Dellara Pty Ltd

Report for Modifications to Modified Preferred Project Overview Report

September 2011

Figure 13 Final Landform and Landscaping

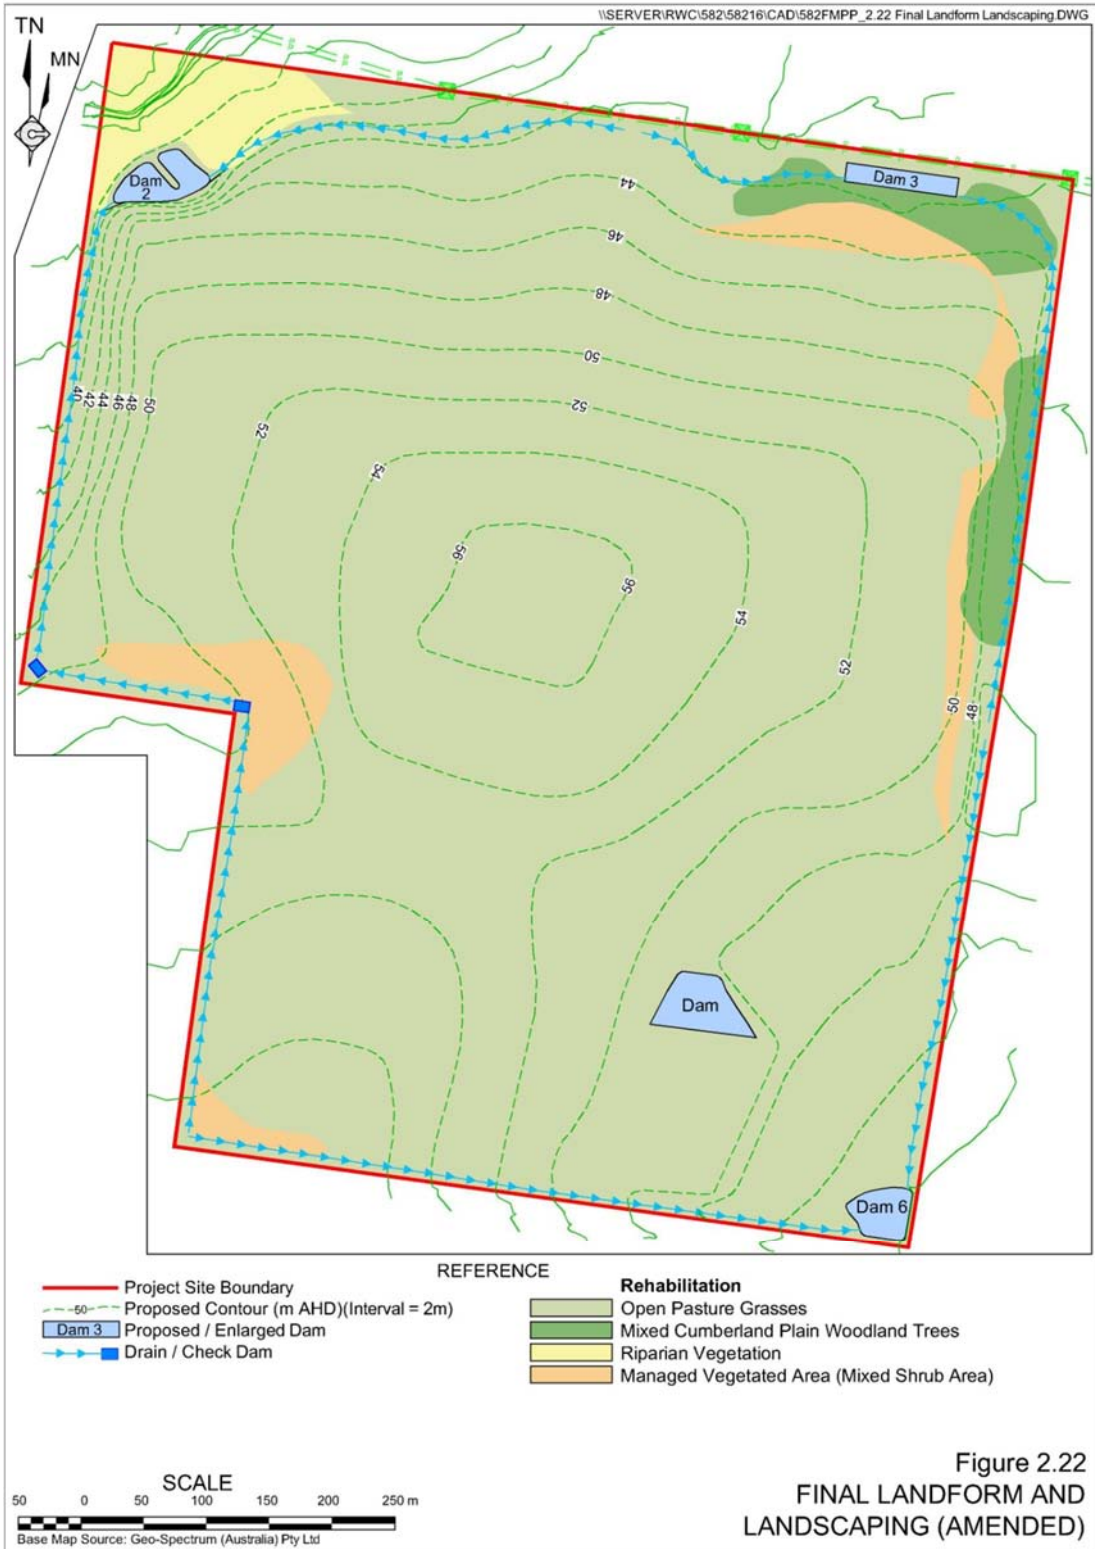
Following initial stabilisation, the entire northern face, the nearby riparian zone adjoining Blaxland Creek and the eastern fence would be revegetated with native trees and shrubs. This is illustrated in **Figure 13**.

Figure 1 – Cumulative Leachate Volume

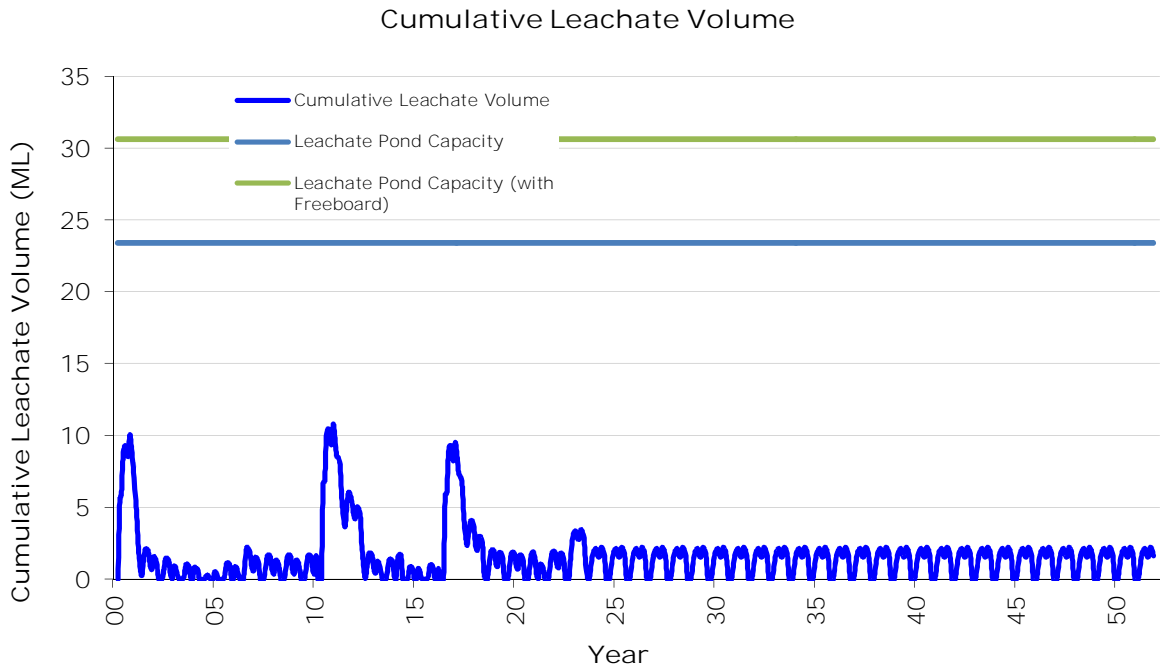
These changes are predicted to result in a smaller volume of leachate being generated by the proposal and requiring disposal. This is mainly because the leachate volumes would be less as the footprint of the landfill would be reduced and correspondingly the area contributing to leachate generation is also reduced. To confirm this view we have re-run our revised leachate model as presented in our Statement of Evidence dated 8 July 2011. This re-run model includes groundwater inflow into Cell 2 and the amendments agreed with Mr David Ife at the Joint Conference, and the discussions with Mr David Ife on the draft conditions of consent in terms of the areas of the active cell which contribute rainfall run-off and overlapping operations for a three month period of time when each cell is capped and revegetated and operations commence in the following cell. The results of this re-run model are presented in **Figure 1**.

It can be seen from **Figure 1** that at all times during the operation of the landfill or during the post closure period that the volume of leachate predicted to be generated is able to be managed on-site. This
